**OU1 Design Change and Modification Sheet:  
Change/Modification # 36**

Property ID: \_\_\_\_\_ Operable Unit 1 \_\_\_\_\_

# OU1 PARKING AREA MODIFICATION

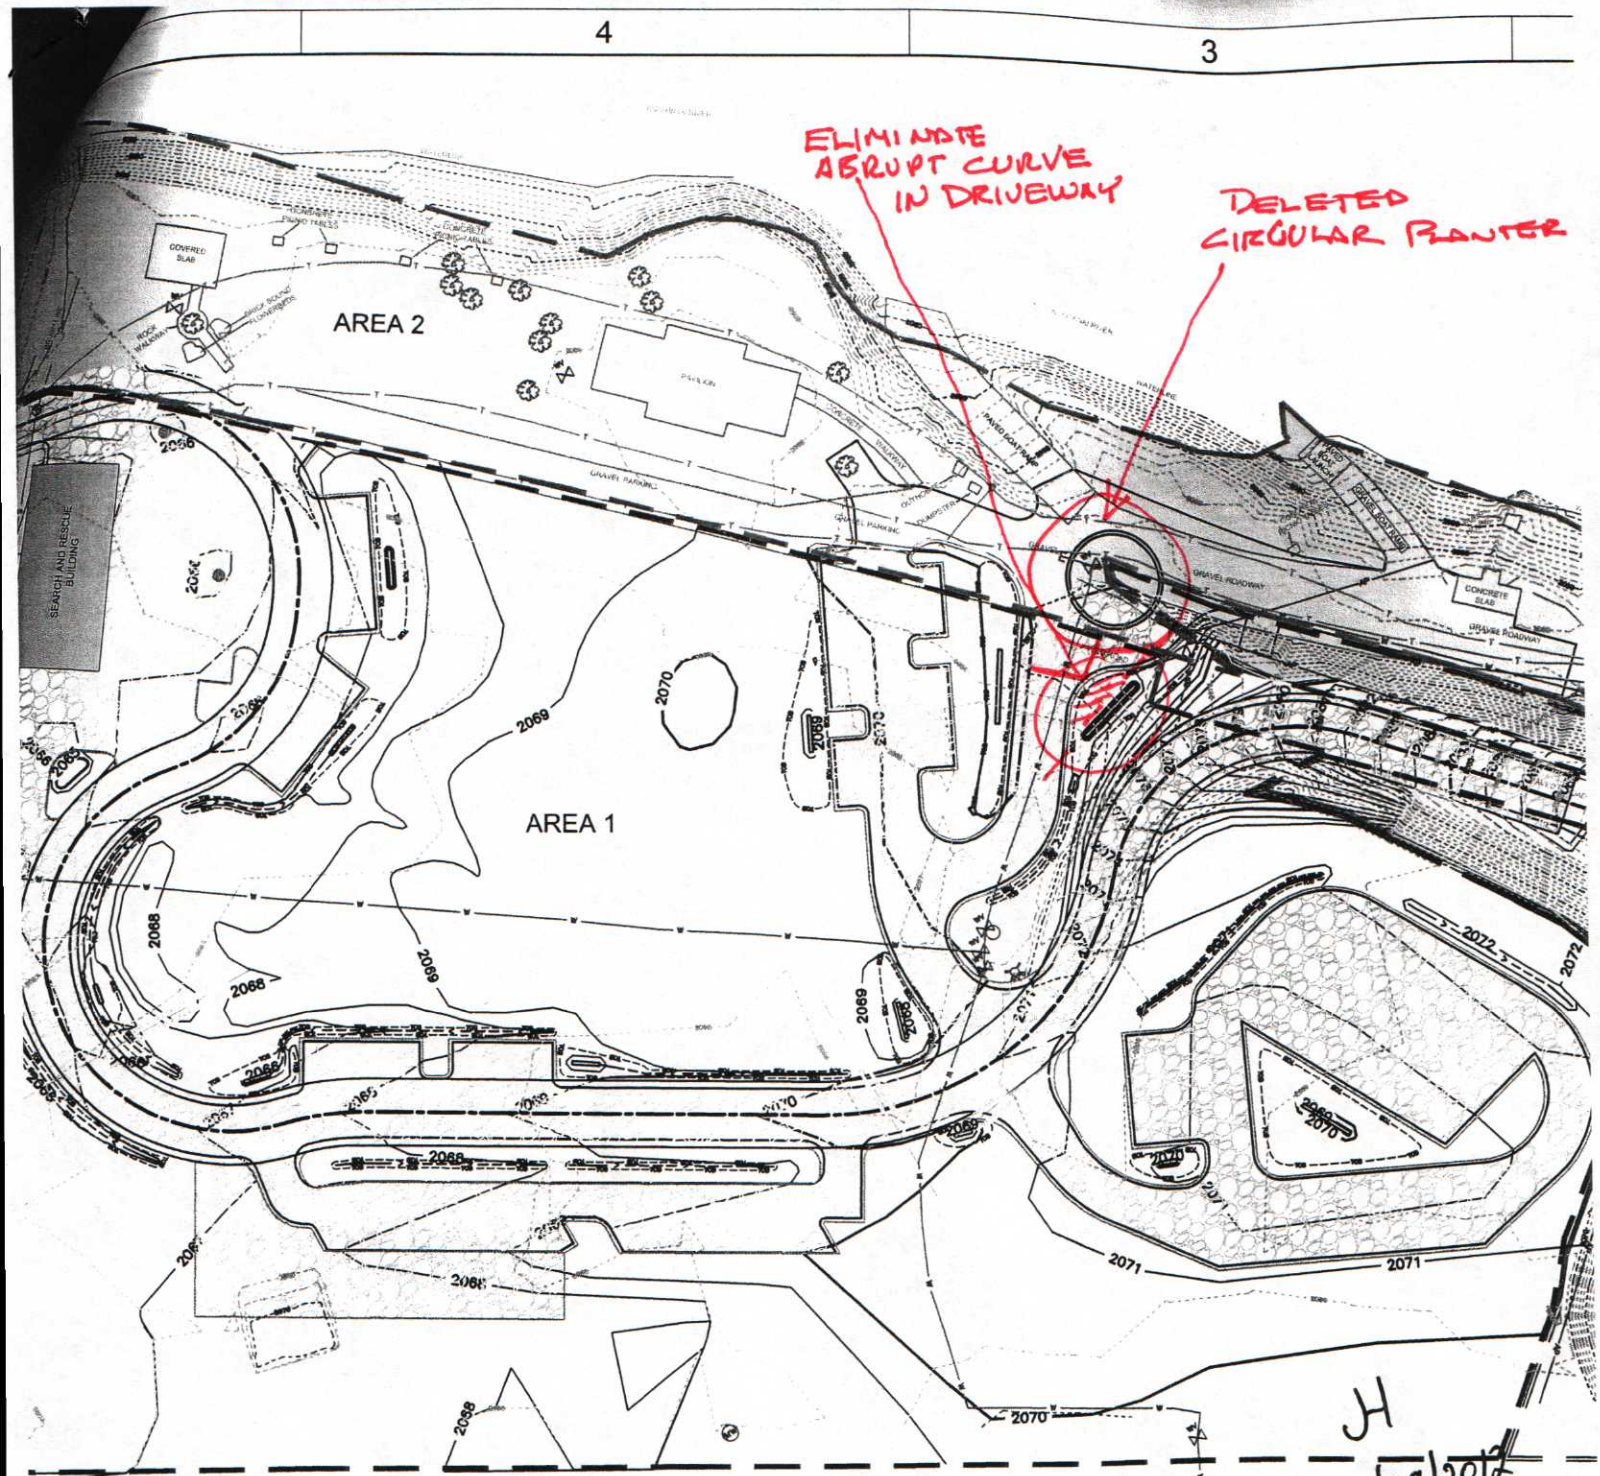
Sheet C6, Driveway to the boat ramps. Eliminate remainder portion of circular planter area and modify the curvature of the drive to the east of the circular planter to eliminate abrupt curve in drive.
